AGENDA

LOCAL TRAFFIC COMMITTEE MEETING

MONDAY 16 AUGUST 2021

Subject: 182-198 VICTORIA ROAD AND 28-30 FAVERSHAM STREET,
MARRICKVILLE – DA 201900096 – CONSENT CONDITIONS 30 AND 31 –
AMENDED SIGNS AND LINE MARKINGS PLAN FOR HANS PLACE AT
FAVERSHAM STREET N156271-08-01 (MIDJUBURI - MARRICKVILLE
WARD / SUMMER HILL ELECTORATE / INNER WEST PAC)

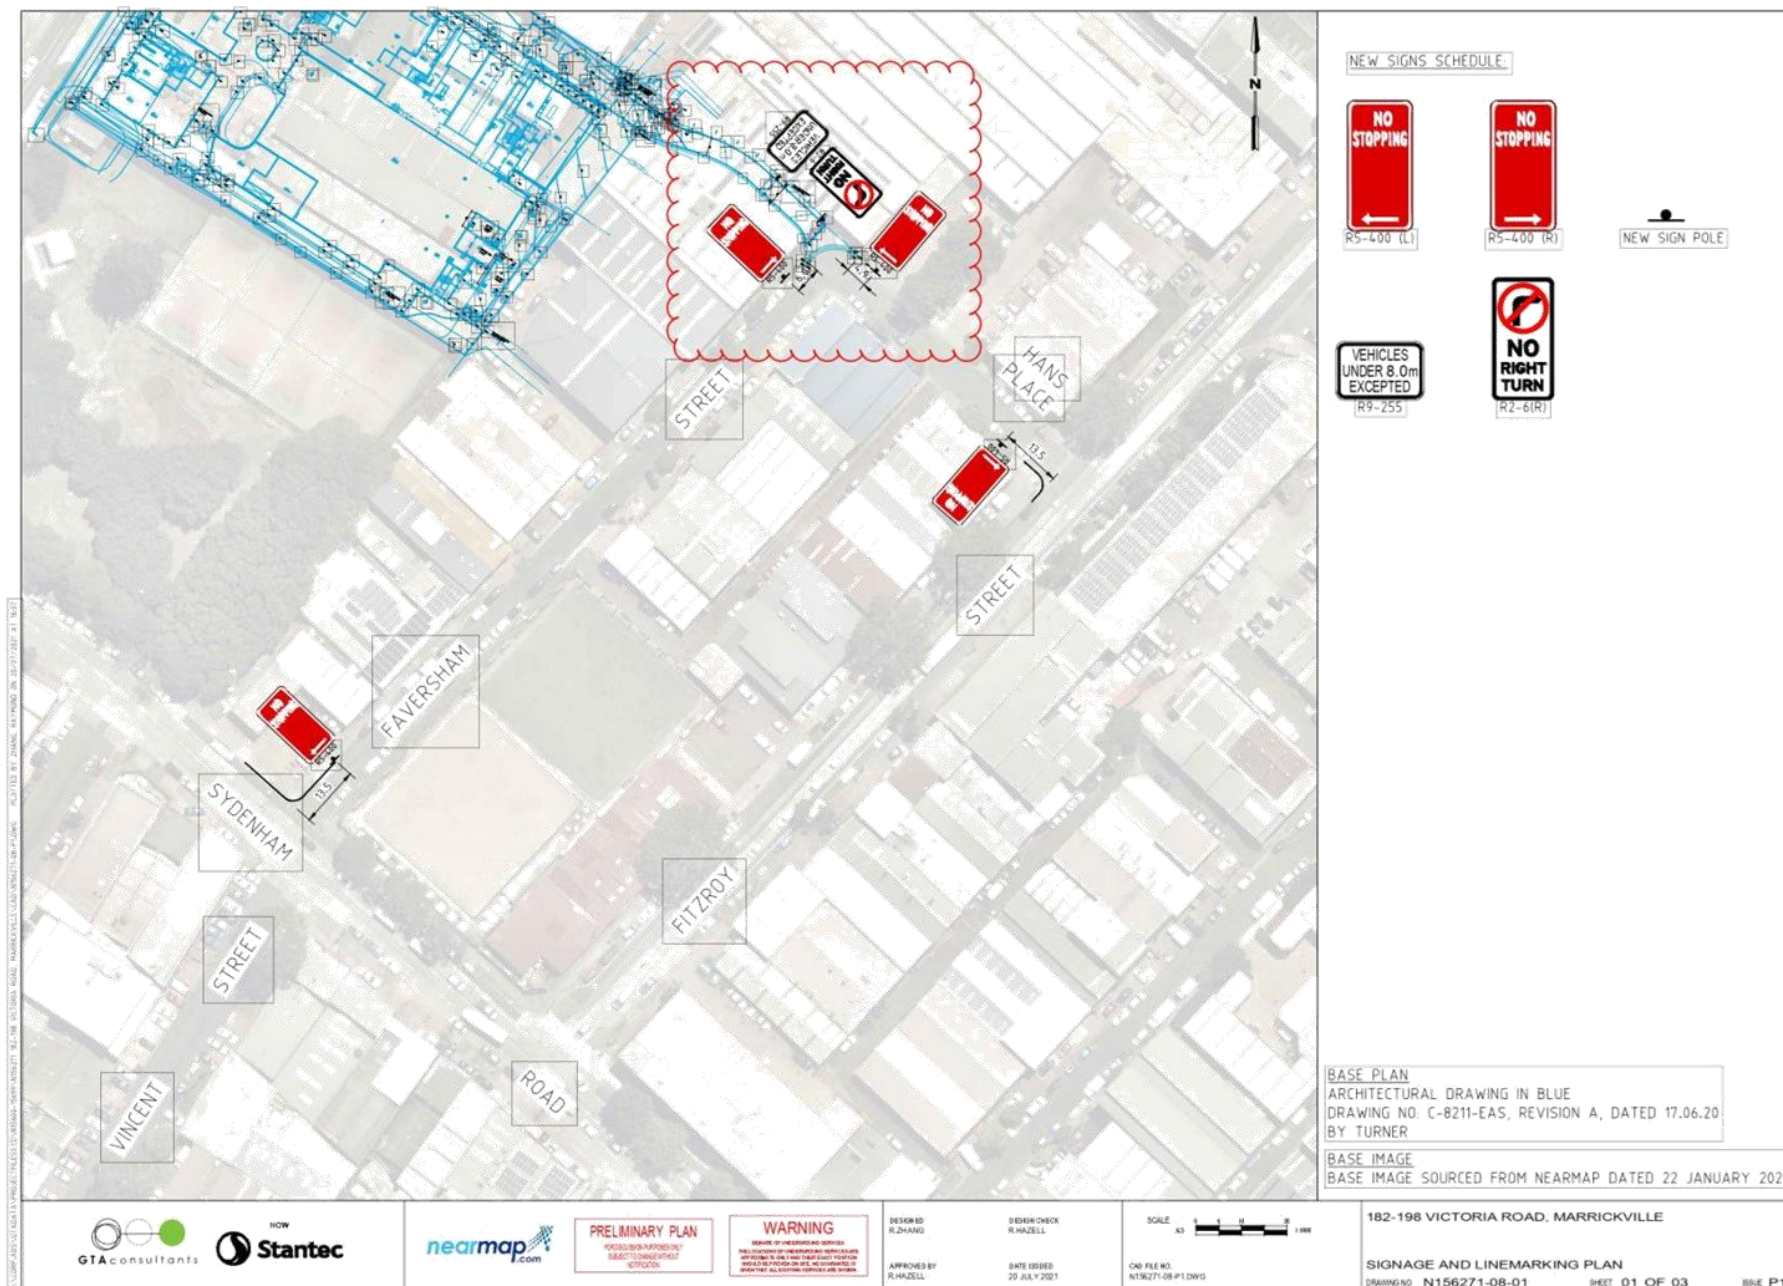
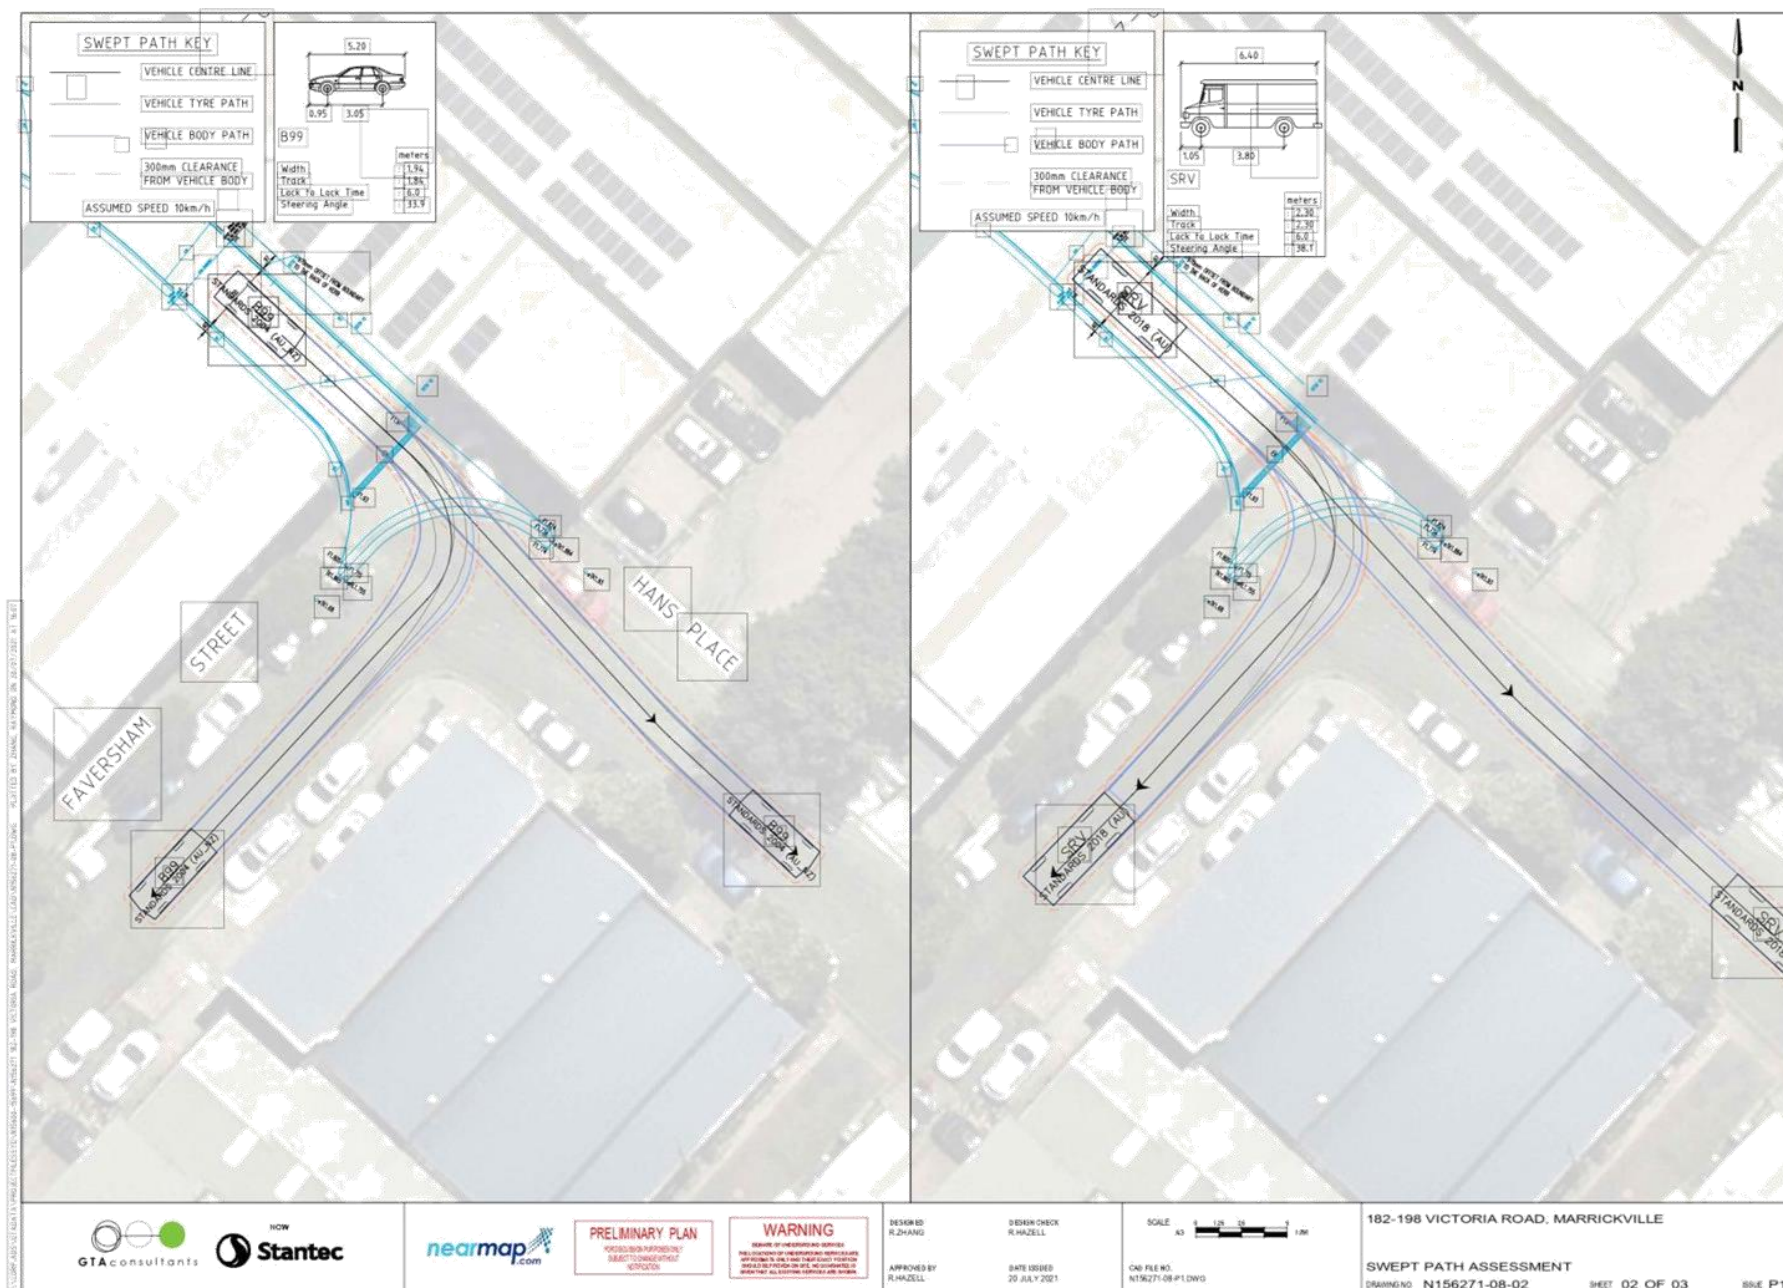
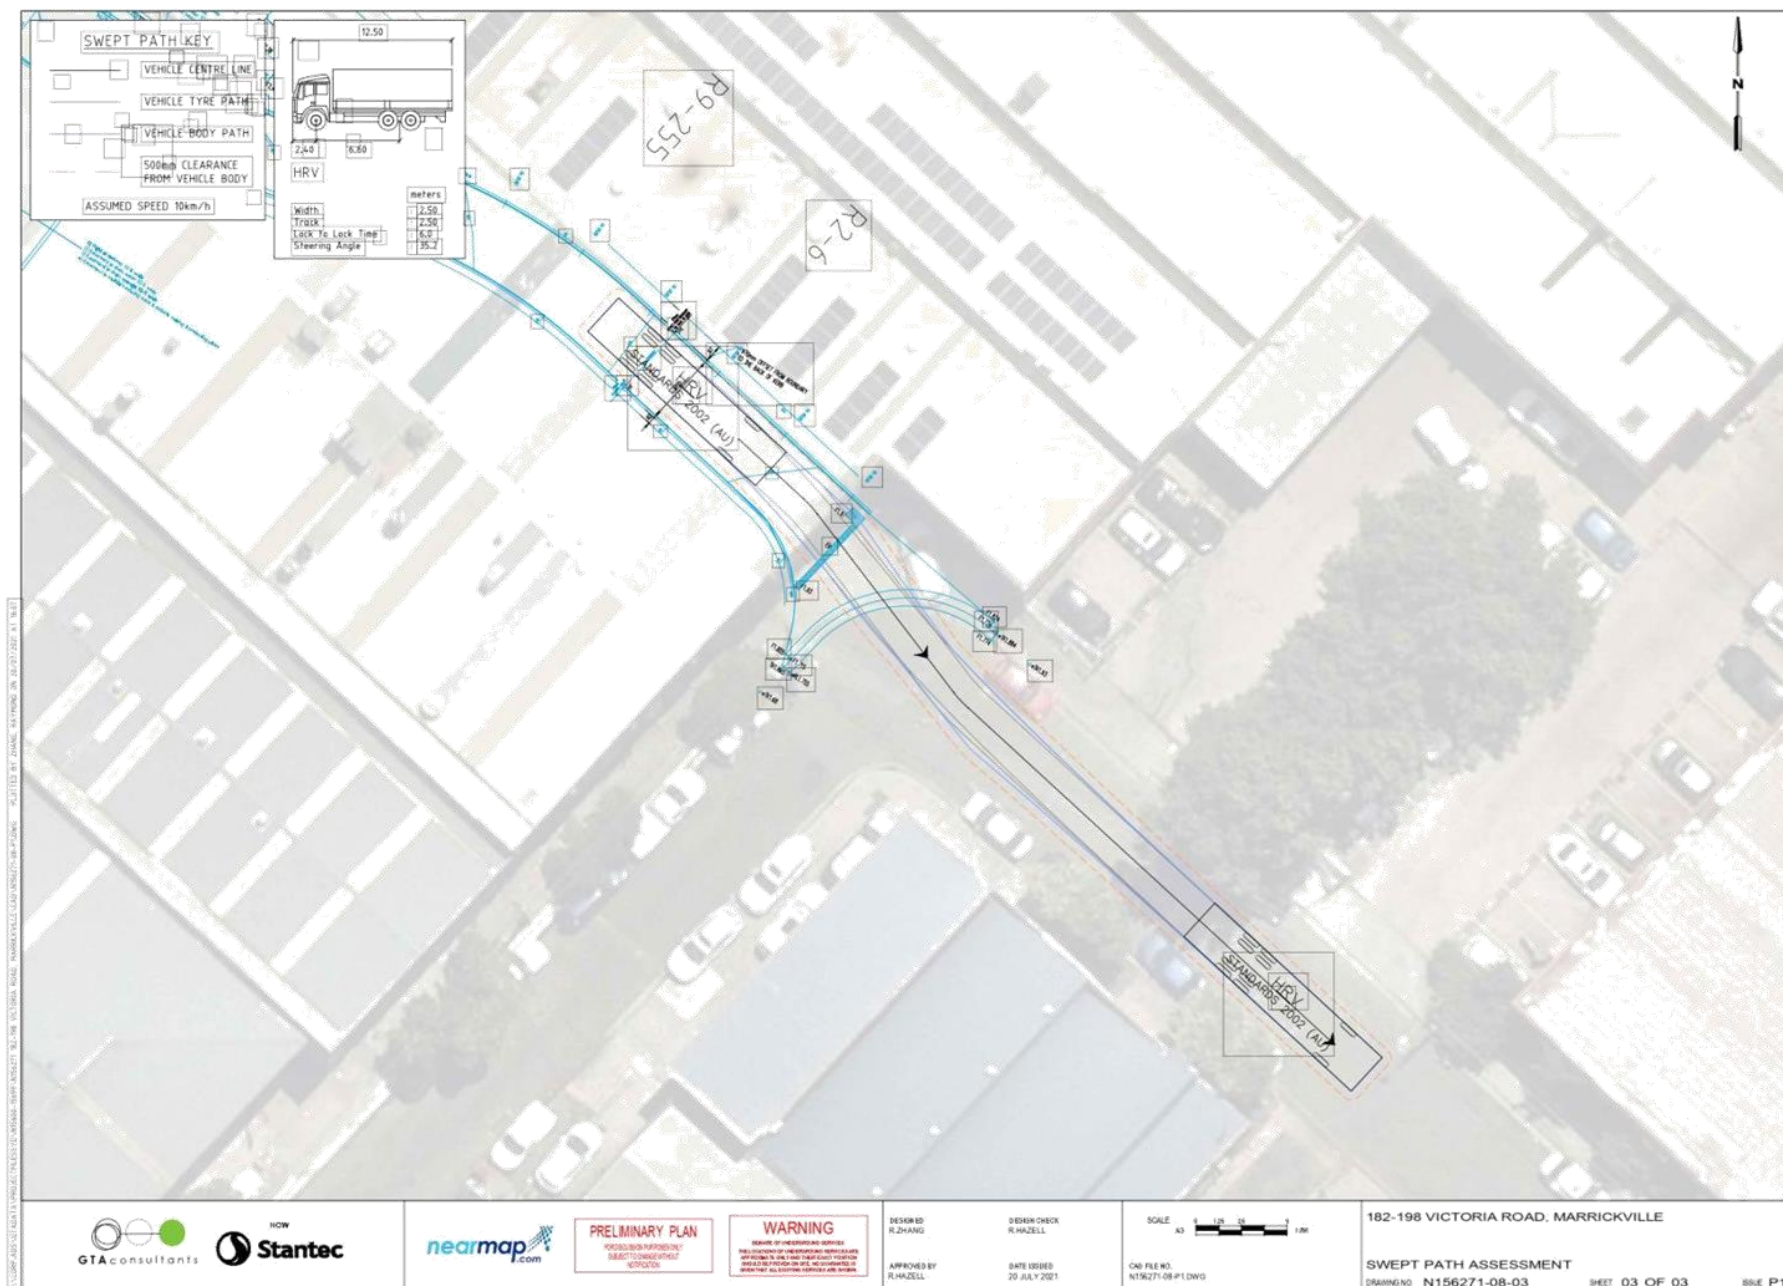
A report went to the Committee at its 15 February 2021 meeting (LTC0221 – Item1) detailing the signage and line marking plans to satisfy DA201900096 consent conditions 30 and 31 (Plan B – N156271-06-02 and Plan C – N156271-06-01 Victoria Road). These plans were approved at Council's meeting 9 March 2021. An amended detailed line marking and signage plan has now been received by Council for Hans Place and Faversham Street, Marrickville (N156271-08-01).

The approved plan are provided in Attachment 1 and following that is the amended plan in Attachment 2. Changes are enclosed within the 'cloud'. It is recommended that the submitted amended plan be supported in principle subject to concurrence of TfNSW that no TMP is required. No further consultation is considered necessary due to it being a new section of road.

1. The amended detailed line marking and signage plan for Hans Place and Faversham Street, Marrickville showing new 'No Stopping' restrictions and a new 'No Right Turn' ban for vehicles over 8 metres exiting the private access way (as per the attached Plan B – N156271-08-01) be approved; and
2. The costs of the supply and installation of the associated signage are to be borne by the applicant in accordance with Council's Fees and Charges.

1. [↓](#) Grosvenor Crescent- Detour Map
2. [↓](#) Grosvenor Crescent- Traffic Control Plan (TCP)

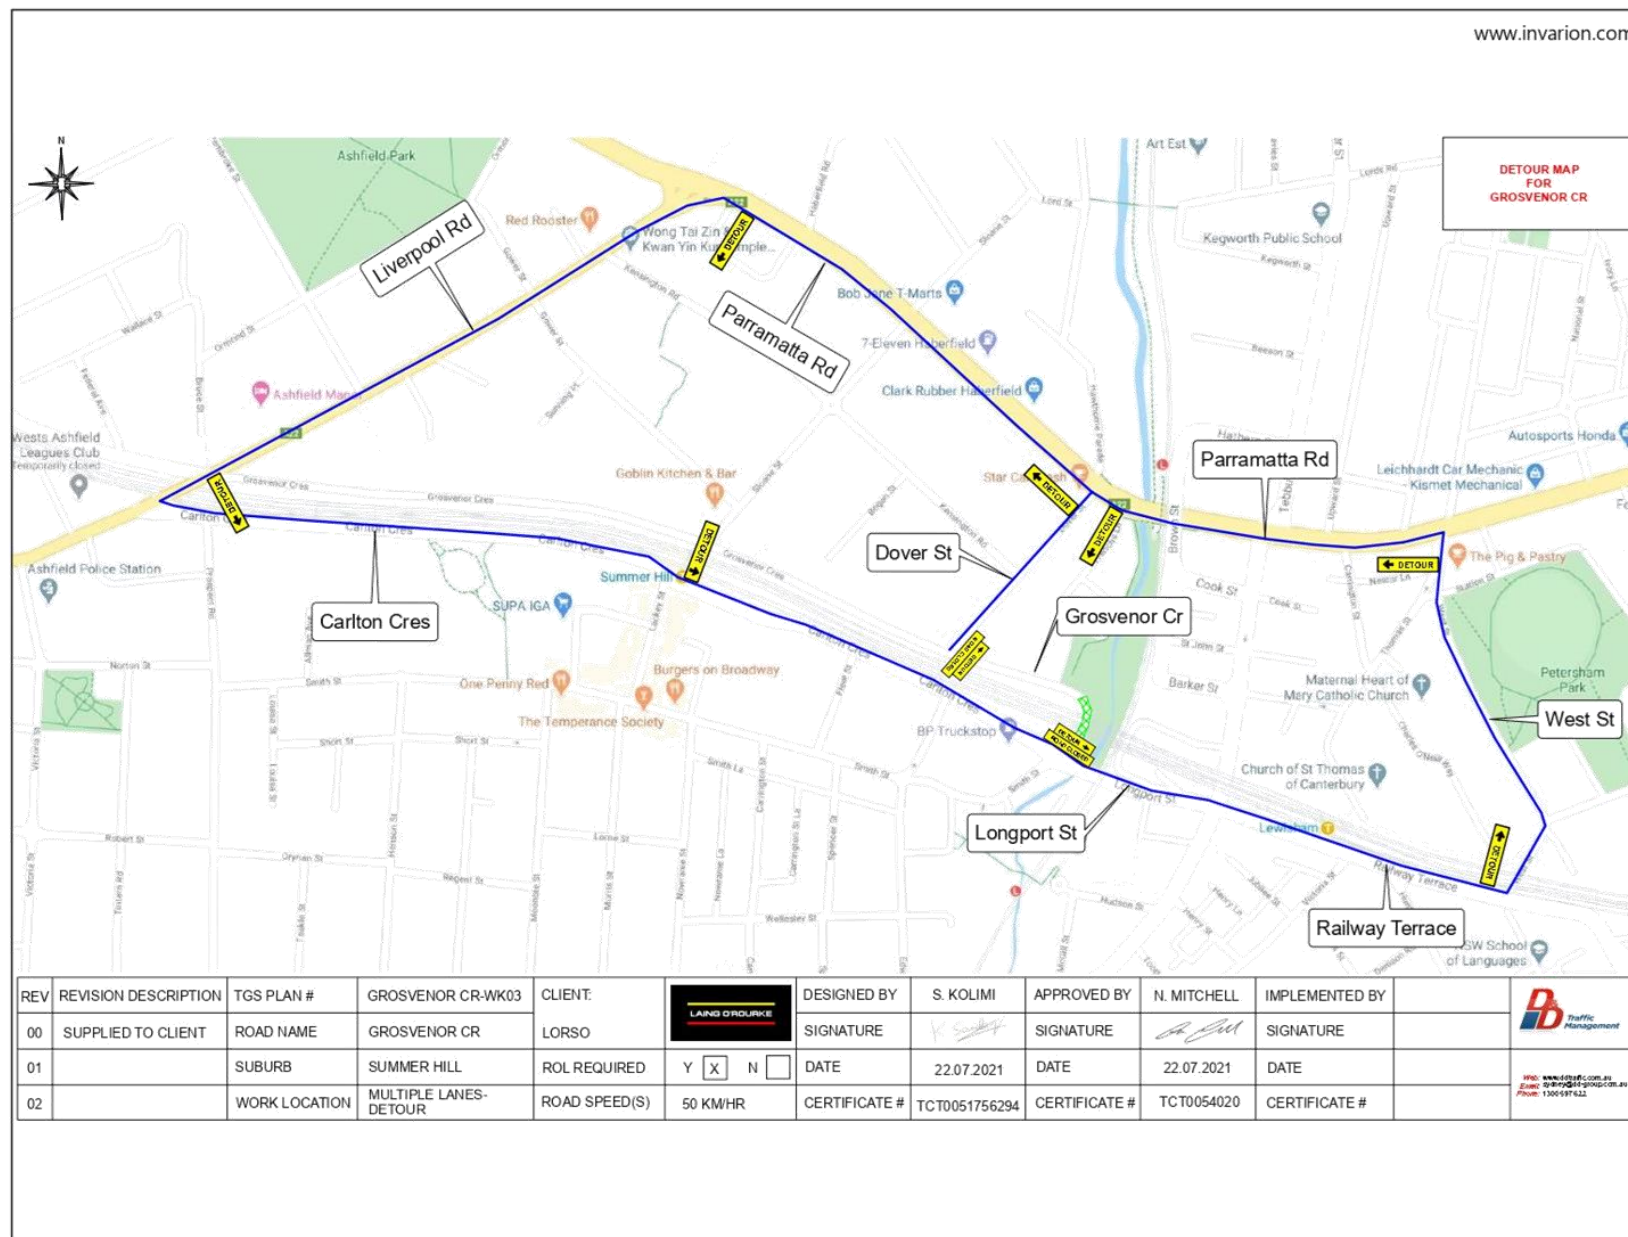
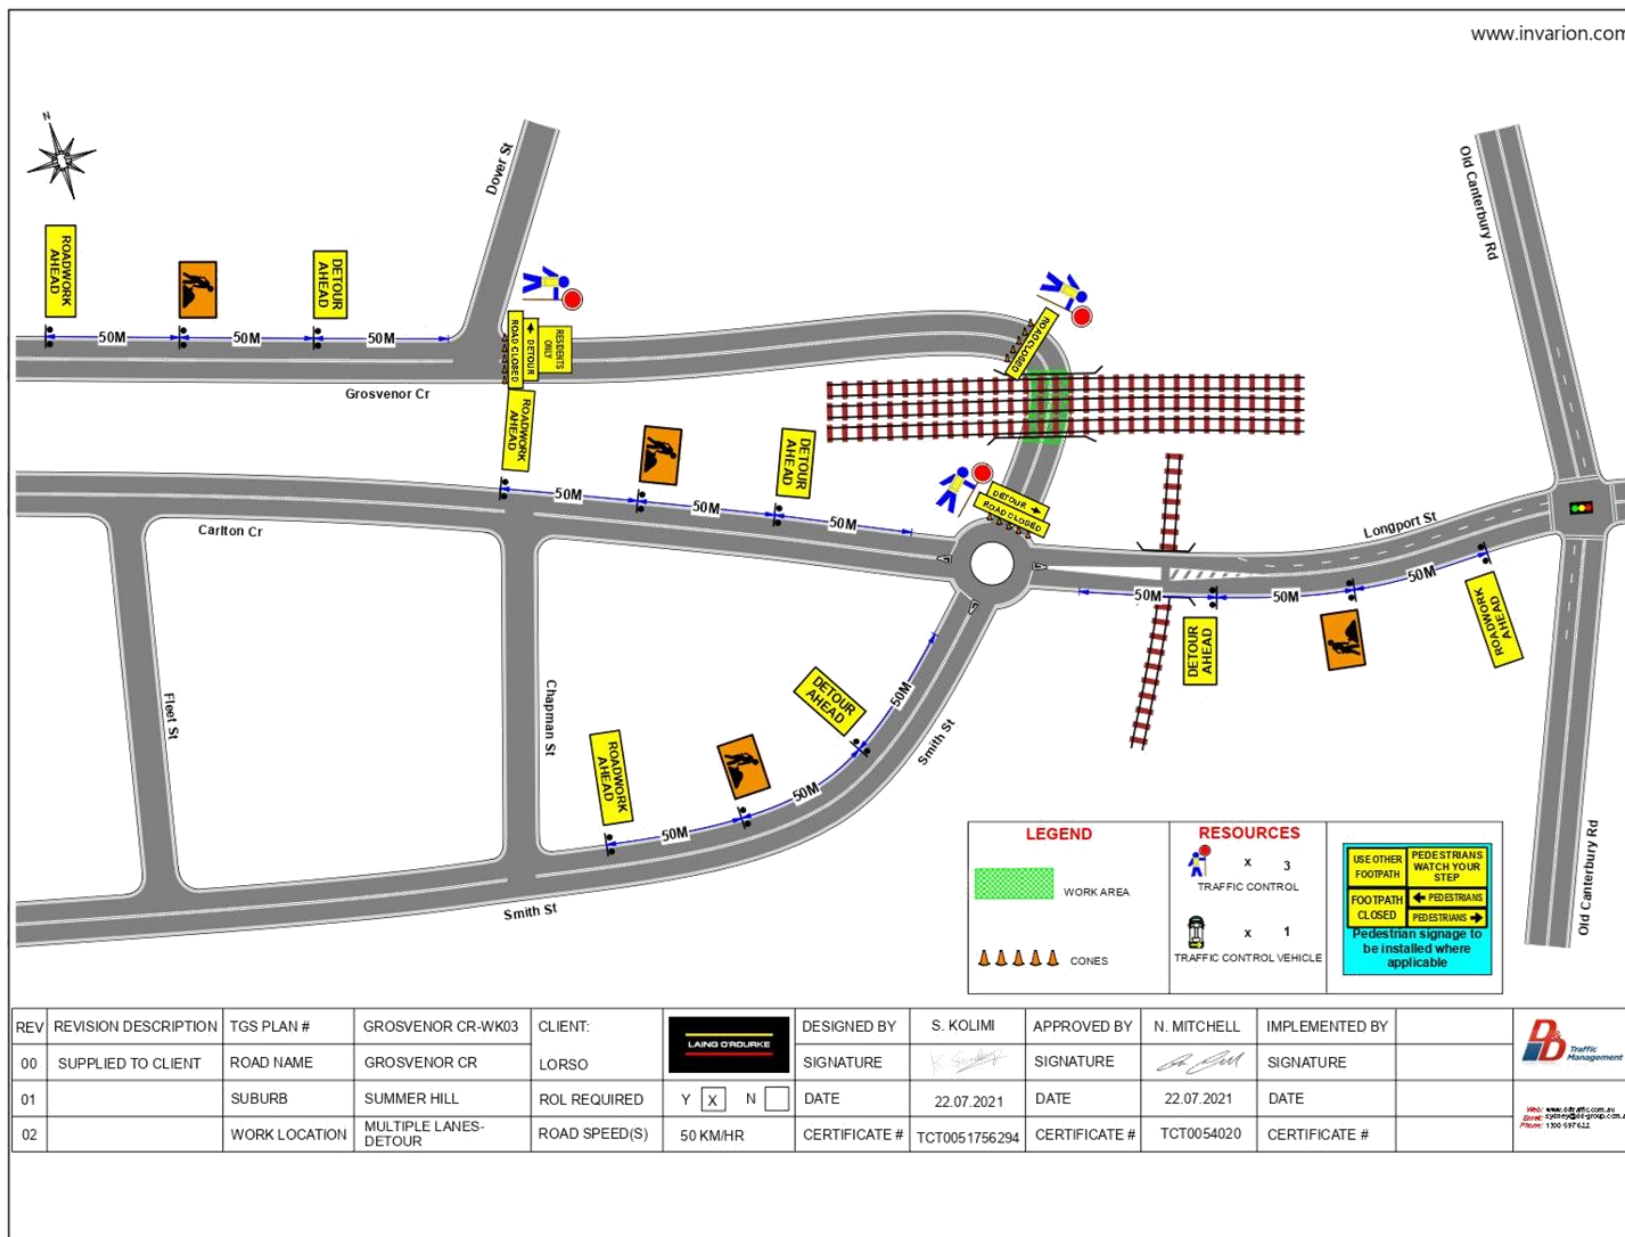
The applicant has been advised to amend their TCP to include electronic variable message signage (VMS) at all approach locations to the closed section of Grosvenor Street and placed out at least 14 days prior to the closure. This allows motorists beforehand to determine and seek alternate routes around the closure.

1. A Traffic Management Plan (TMP) for the attached Traffic Control Plan (TCP) be submitted to TfNSW prior to the start of works;
2. The Traffic Control Plan (TCP) be amended to include electronic VMS notification boards at all approaches to the closed section of Grosvenor Street and placed out at least (14) day prior to the closure. The boards are to be positioned at locations and worded appropriately to the satisfaction of Council;
